Letter of explanation

PROJECT NOTIFICATION APPLICATION

Project Name (site name, subdivision name, or other) Holly Hill Harbor

CONFIRMATION OF PRE-FILE (2025-0035-P)

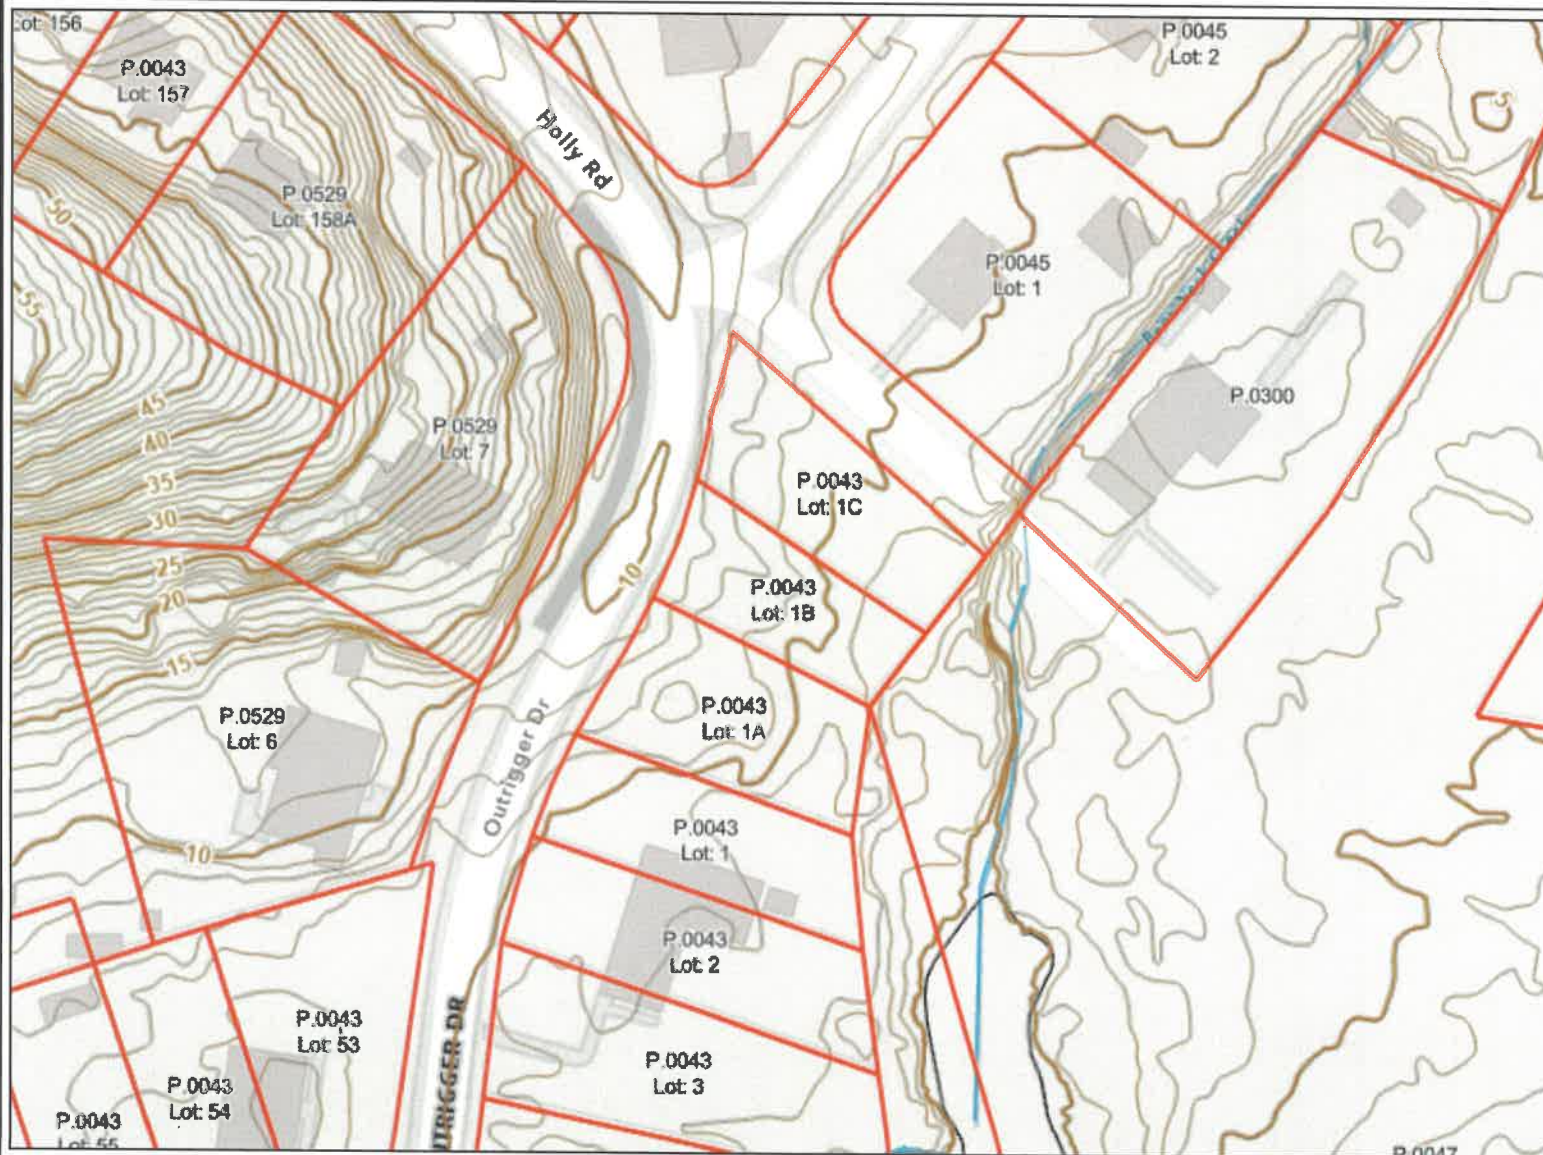
(3) SITE INVENTORY: Existing/Created/Removed Trees = canopy area of trees on the lot (the treeline appears to be shown on the site plan)

No trees are disturbed during this process. All trees are on the left side of the yard. The deck will be on the rear of the house.
